## PROGRESSIVE INDEX FOR 1963 SERVICE LETTERS

## WIRING LOOM CONNECTIONS

### "Anglia Super"

Fig. 1. Modified Loom Pliers for Moulded Type Terminals

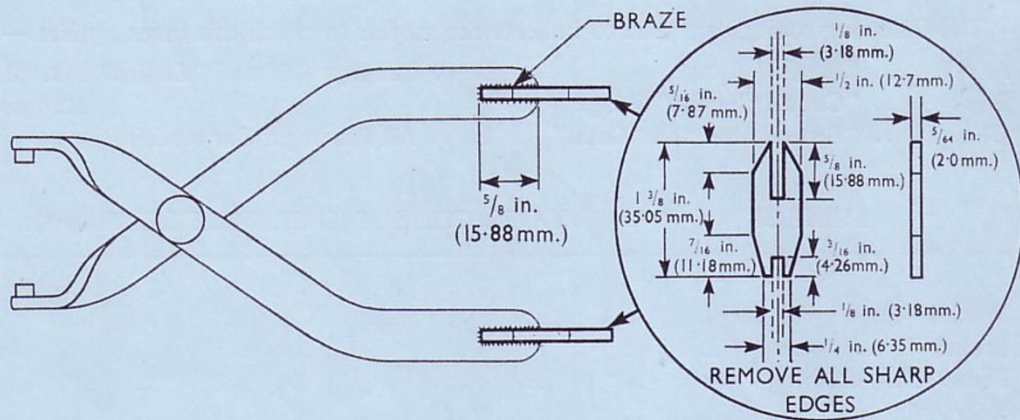
An additional type of snap connector is now used on certain models in production and this has moulded insulation on the snap terminals and connector sleeves. Although this method of construction reduces the possibility of short circuits should the terminals not be pressed fully home, wiring loom pliers should still be used to ensure correct assembly.

Existing loom pliers, as illustrated in Service Letter No. 13 (Export) 1961 Series, may be further modified for the latest connectors by welding or brazing a suitable spade end onto the plier handles, as illustrated in Fig. 1 (overleaf).
